ADDITIONAL REPRESENTATION submitted for and on behalf of CPRE Sussex to application:

SDNP/16/04679/CM

Markwell's Wood-I Well Site, South Holt Farm, Dean Lane End, Forestside, Rowlands Castle West Sussex.

**COMMENTS ON ENVIRONMENTAL STATEMENT AND GROUNDWATER RISK ASSESSMENT BY HYDROCK
CONSULTANTS LTD ON BEHALF OF UKOG (GB).**

Fig. 1

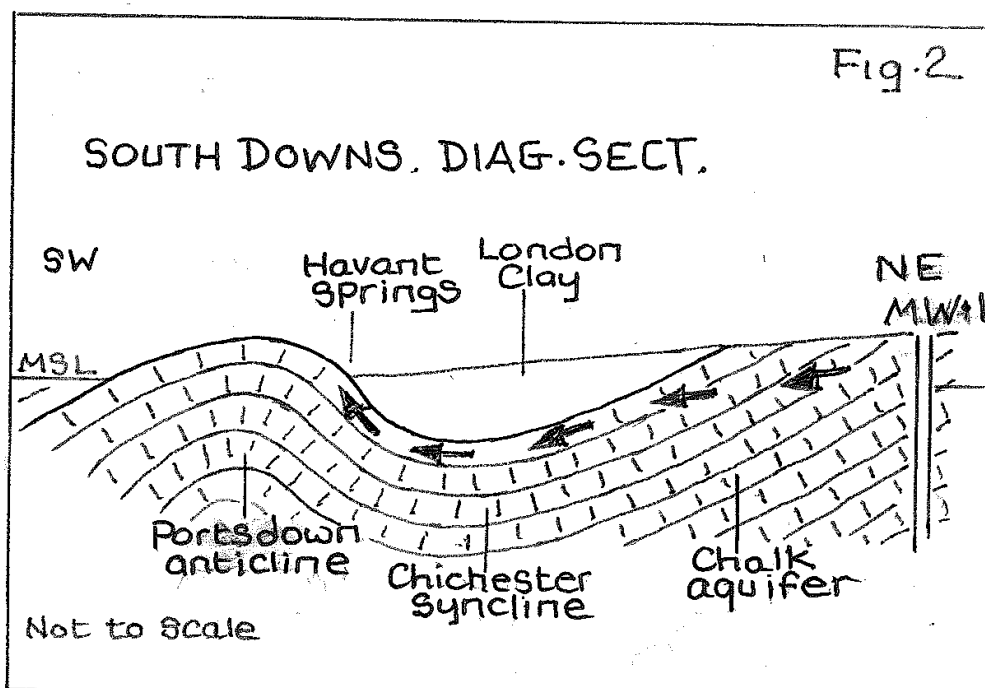
2.1. The main components of the geological succession are shown in Fig.1, based on the

lithological records for MWI and reproduced from Tables 3.1 -3.2 of the Hydrock Groundwater Risk Assessment of Sept 2016 (www.hydrock.com) The upper 576m of the sequence includes 2 principal aquifers: the Chalk comprising 412m of fissured soft limestone, and 87m of permeable sandstones of the Upper and Lower Greensand formations.

2.2. The Chalk and Lower Greensand aquifers have been assessed by Hydrock as in hydraulic continuity, implying that the intervening Gault Clay is not impermeable and would not therefore function as a protective barrier to the migration of hydrocarbons.

Fig. 2

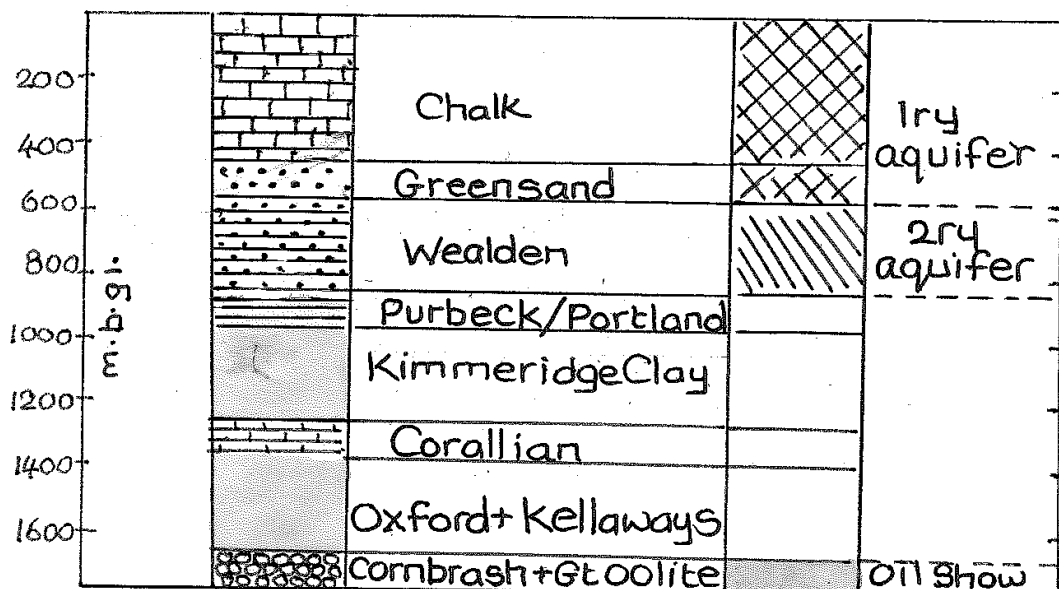
2.4. Groundwater flow is controlled by the local geological structure, characterised by the Chichester syncline and Portsdown anticline (Fig.2). Storage in the aquifer is replenished by rainfall throughout the S. Downs, and in the area NE of the Chichester Syncline, rainfall infiltration reaching the water table will be subject to a general S to SW flow path, taking it below the axis of the syncline to emerge on the Havant/(Bedhampton springline; a straight line distance of approximately 8km (Fig.3) With a mean water table level of approx. 30m AOD and the spring line close to sea level, this would give a hydraulic gradient of about 1 in 270 (or approx. 3.7m/km compared with the Applicant's figure of 1.6m/km).

2.5 It is therefore possible to discern a pathway from a hydrocarbon leakage source at the exploratory borehole site, via a network of fractures and solution fissures, to its outfall at the springs – a strategic public water supply source with a rated average discharge of 144ML/day.
